APPLICATION FOR CERTIFICATE OF APPROPRIATENESS

Address 418 N 23rd Street
Historic district Church Hill North

Description of Changes to Applications for Certificates of Appropriateness:

418 North 23rd Street

A1 EAST ELEVATION
1/4" = 1'-0"

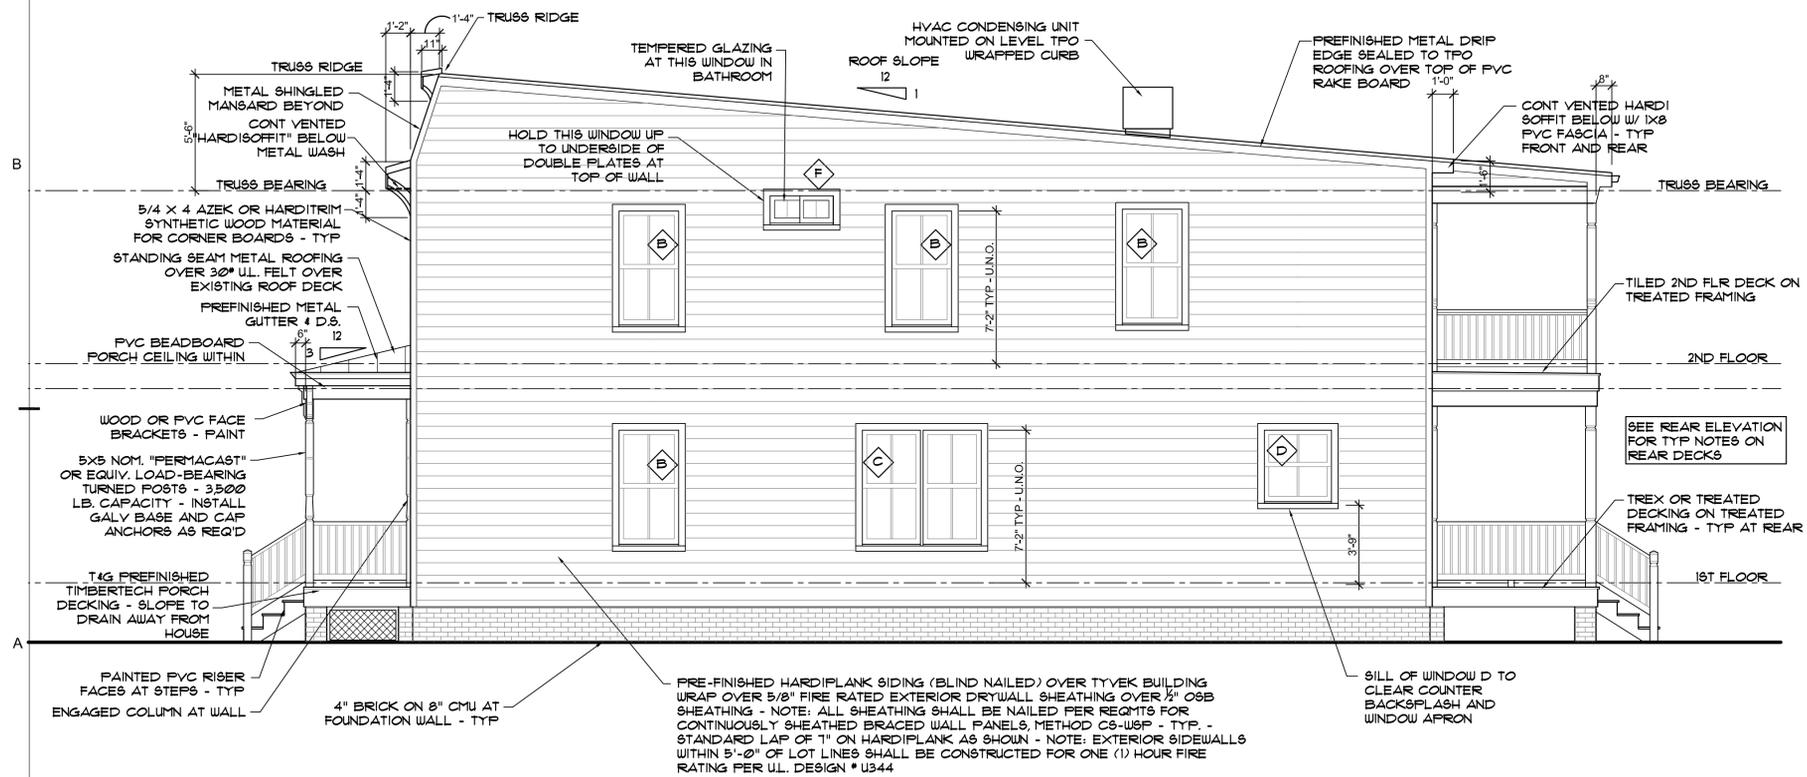
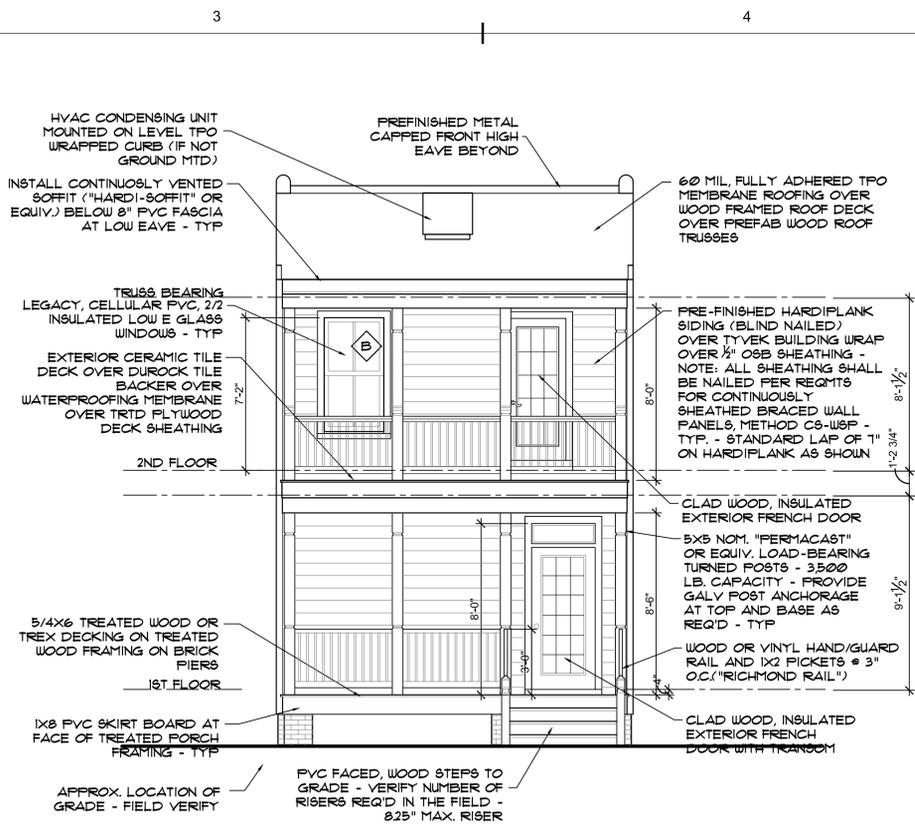
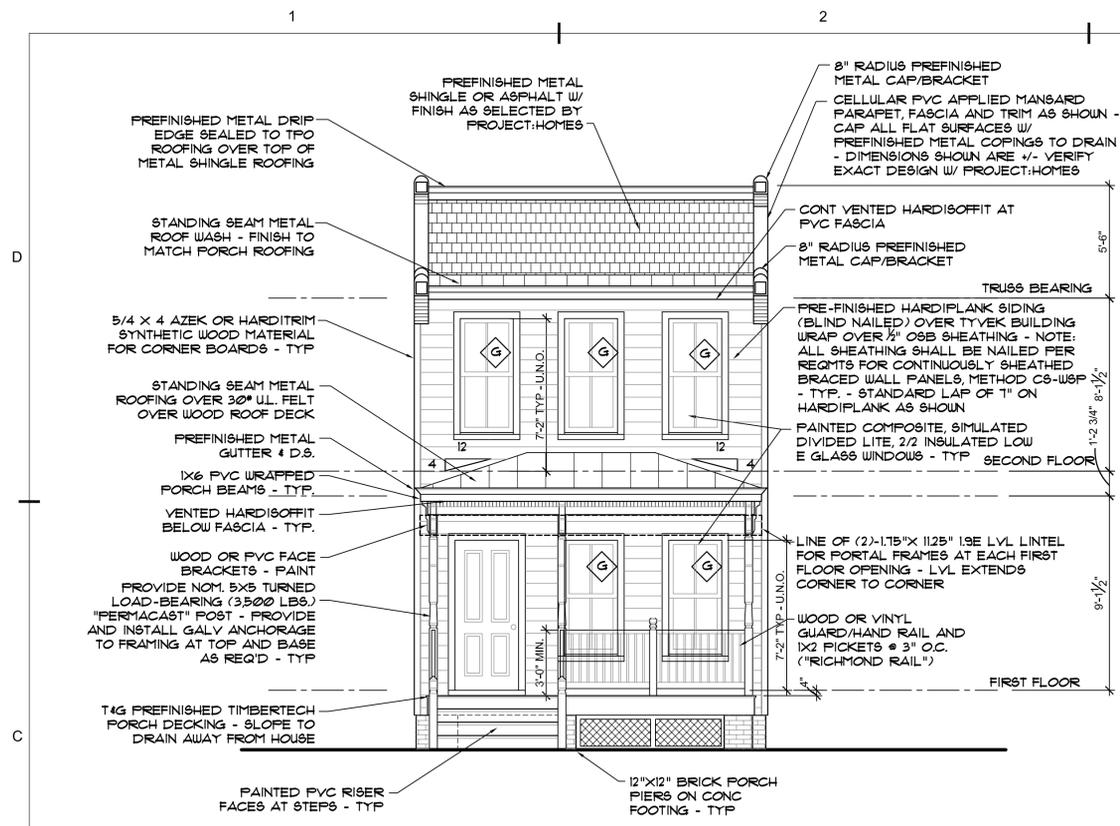
The structural plans have been re-engineered to accommodate Chairman Klaus' request that the twin windows be removed from the front elevation and replaced with aligned and centered individual windows. The current plans and elevation show the changes. The front porch has been inset to prevent the porch gutter from overhanging past the house per Mr. Brewer's request. The downspouts will be installed so as not to block the porch column per Chairman Klaus' request. The decorative brackets have been deleted per Mr. Wheeler's request.
